Change Bulletin

No: CB006

Description: EMI Quill Spline Lock Collar

Figure 1 – Revised Lock Collar Dimensions

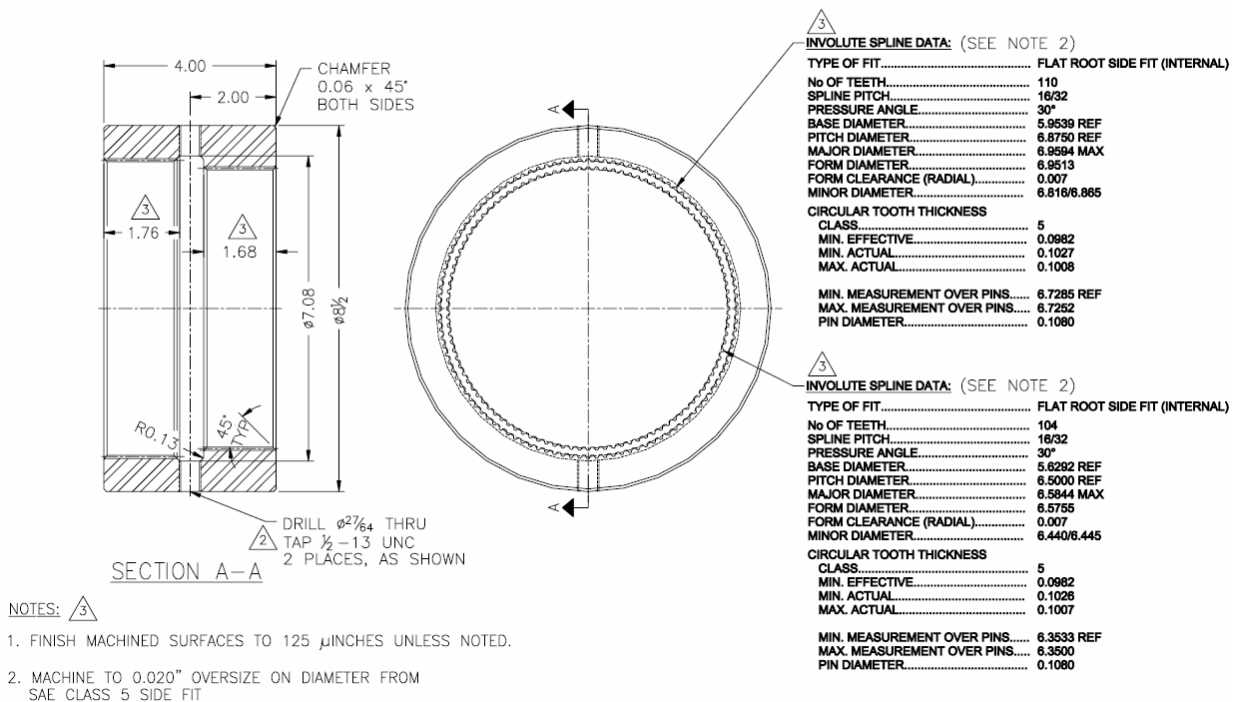
The quill spline lock collar (Tesco P/N 11315) that is used on the EMI 400 and EMI 450 series of top drives was manufactured with a tight spline fit. To improve the ease of installation, the spline dimensions have been modified to include a 0.020 inch oversize on diameter to provide a looser fit. The groove that separates the two splined sections has also been increased in width to improve manufacturability. These modifications are documented in Engineering Change Notification 084-0012. Figure 1 below shows the updated dimensions for the quill spline lock collar; please refer to drawing 30001101 rev. 3 for complete specifications.

If the checks above do not reveal any problems then the spline lock collar should be replaced with one of current manufacture. Alternately, the existing collar may be reworked to the dimensions shown in Figure 1 (ref. drawing 30001101 rev. 3), if required.
